**SANTA FE COUNTY**  
**JACONA COLLECTION CENTER**

**RFP #2016-0263-PW/IC**

**ADDENDUM #2**

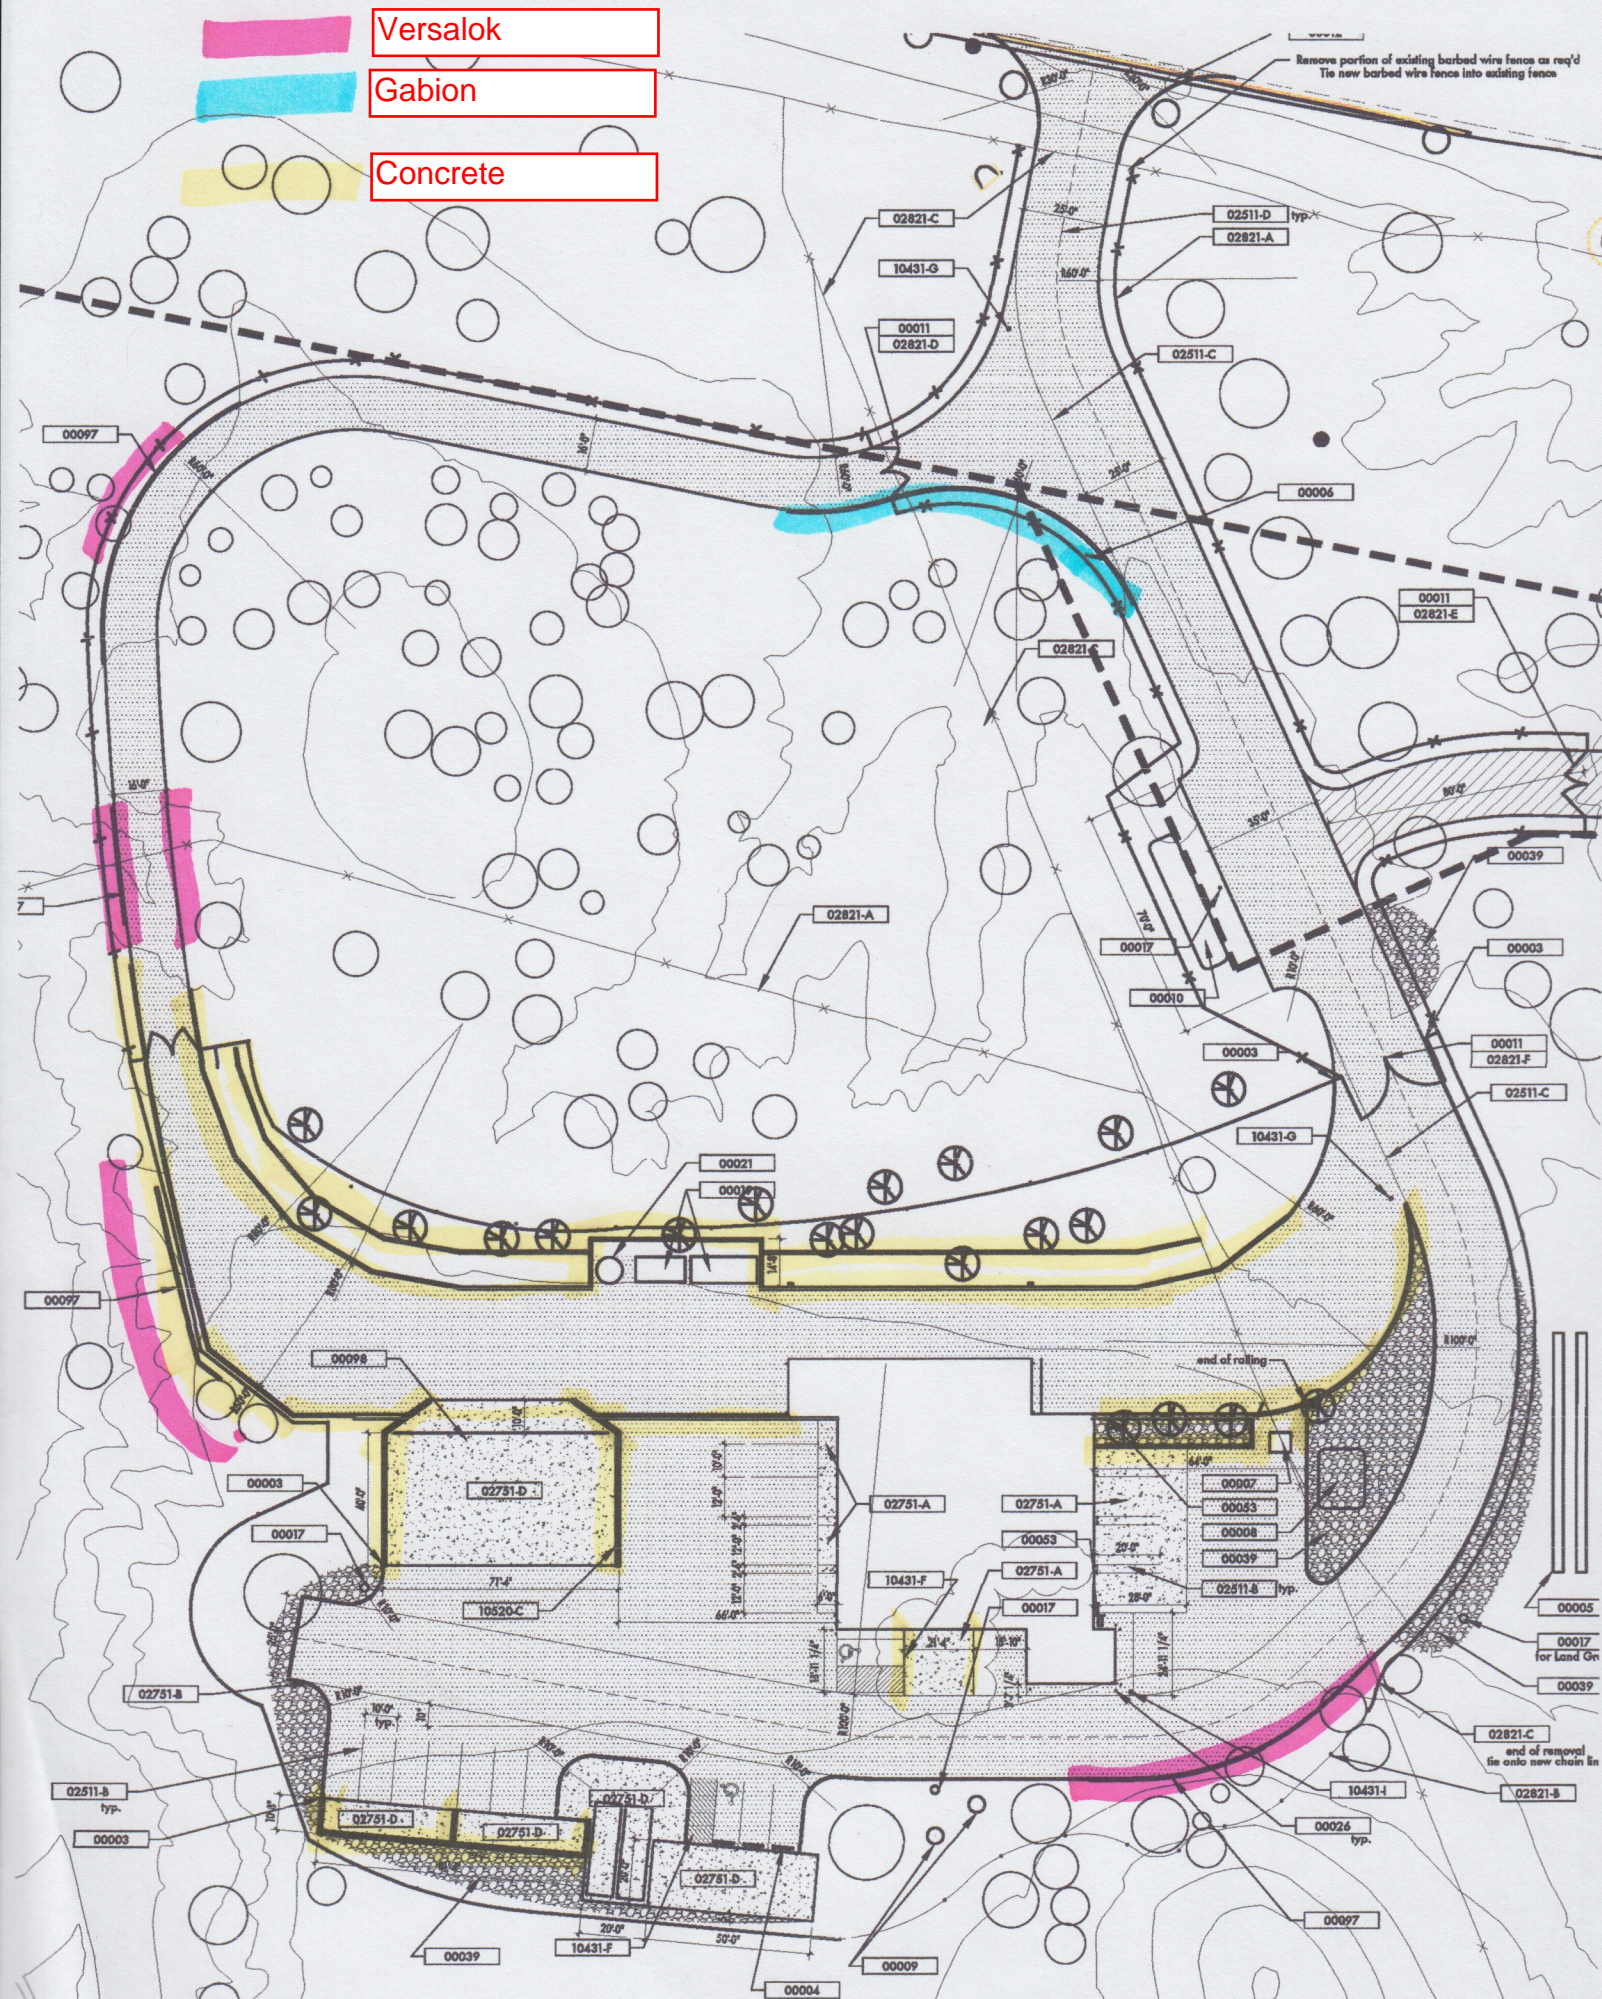
**9. Spec. Section 133419**

The Metal Building is a Basis-of-Design specification per Spec. Section 133419.2.1.A. Per 2.1.A.1: "The RIGID Global Buildings specification (included in this section) shall be used as a performance specification for the metal building system." The specification does not limit the manufacturers that can provide designs for the project.
